APPLICATION NO.	FILING DATE	FIRST NAMED INVENTOR	ATTORNEY DOCKET NO.	CONFIRMATION NO.
10/679,592	10/06/2003	Dirk Weichholdt	09201-US 5952	
7:	590 05/21/2004		EXAMINER	
DEERE & COMPANY			KOVACS, ARPAD F	
One John Deere Place Moline, IL 61265-8098			ART UNIT	PAPER NUMBER
			3671	
		DATE MAILED: 05/21/2004

Application N .	Applicant(s)			
Office Action Commence	10/679,592	WEICHHOLDT ET AL.			
Offic Action Summary	Examiner	Art Unit			
the second secon	Árpád Fábián Kovács	3671			
Th MAILING DATE of this communication apperent of r Reply	ears on the cover sheet with the c	orrespond nce address			
A SHORTENED STATUTORY PERIOD FOR REPLY IS SET TO EXPIRE 3 MONTH(S) FROM THE MAILING DATE OF THIS COMMUNICATION. - Extensions of time may be available under the provisions of 37 CFR 1.136(a). In no event, however, may a reply be timely filed after SIX (6) MONTHS from the mailing date of this communication. - If the period for reply specified above is less than thirty (30) days, a reply within the statutory minimum of thirty (30) days will be considered timely. - If NO period for reply is specified above, the maximum statutory period will apply and will expire SIX (6) MONTHS from the mailing date

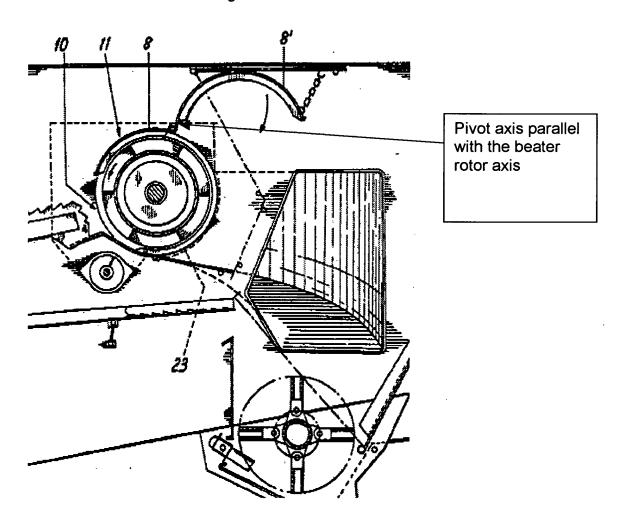
- (b) the invention was patented or described in a printed publication in this or a foreign country or in public use or on sale in this country, more than one year prior to the date of application for patent in the United States.
- 3. Claims 1-2 are rejected under 35 U.S.C. 102(b) as being anticipated by Esserting et al (5021028).

Kersting discloses & shows:

1. A combine having an axial separator, the axial separator is provided with an outlet in communication with a discharge beater, the discharge beater can convey crop material other than grain discharged by axial separator to a straw chopper, a straw guide element is arranged between the discharge beater and the straw chopper, characterized by the fact that the straw guide element is movable around a pivot axis between a chopping position, in which the crop material other than grain enters the straw chopper, and a longitudinal straw delivery position, in which the crop material other than grain is expelled from the combine unchopped.

(col. 2, ln 60-66; fig 2, 3)

2. The combine as defined by claim 1 wherein the discharge beater has a rotational axis and the pivot axis of the straw guide element is parallel to the rotational axis of the discharge beater.
